Memo

Re: Consultation on an Application

Planning Application Ref: PL/26/0804

Proposal: Proposed single storey rear / 2 Storey side & a garage conversion.

With reference to the LOCATION & BLOCK PLAN, May 2026, Drawing No. P1595-01, and the Arboricultural Report, 30th January 2025, Ref: MW.2501.LCR.AIA, Rev: A (Issued 13th May 2025), the arb report is not reflective of the current proposal and is that submitted for PL/25/0233:

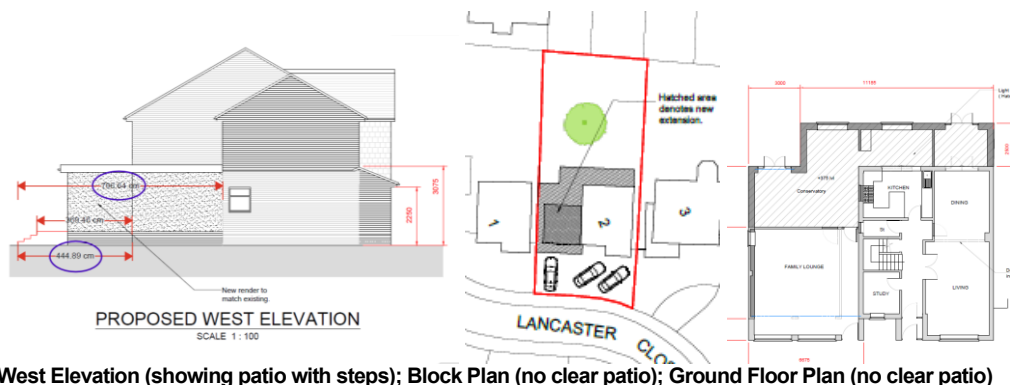
As advised in my pre-application advice, an updated AIA/AMS will be required which has not been submitted. The rear extension is within the RPA of the protected T5 Pine (along with the protected T3 Pine in the neighbouring property), and the garage conversion/side extension is also within the RPA of the protected T5 Pine, hence it is necessary to demonstrate how these will be constructed whilst minimising the impact to tree health. The proposal is not acceptable as it has not been demonstrated how these elements will be constructed whilst minimising the excavation and impact on the RPA – this AIA has not been revised hence unacceptable as PL/25/0223 was.

Ground Floor Plan (room for unknown use)

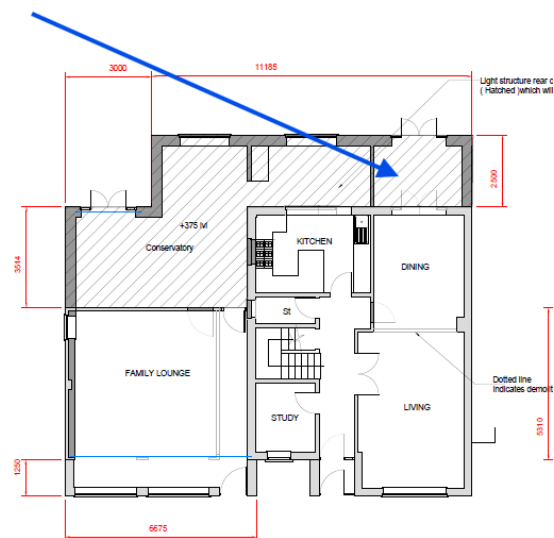
When we visited for pre-application advice, the applicant advised us this would effectively form a white goods room/kitchen area. It is relevant in terms of considering the tree impact of the proposal for the use of the room to be clarified, due to associated service routes.
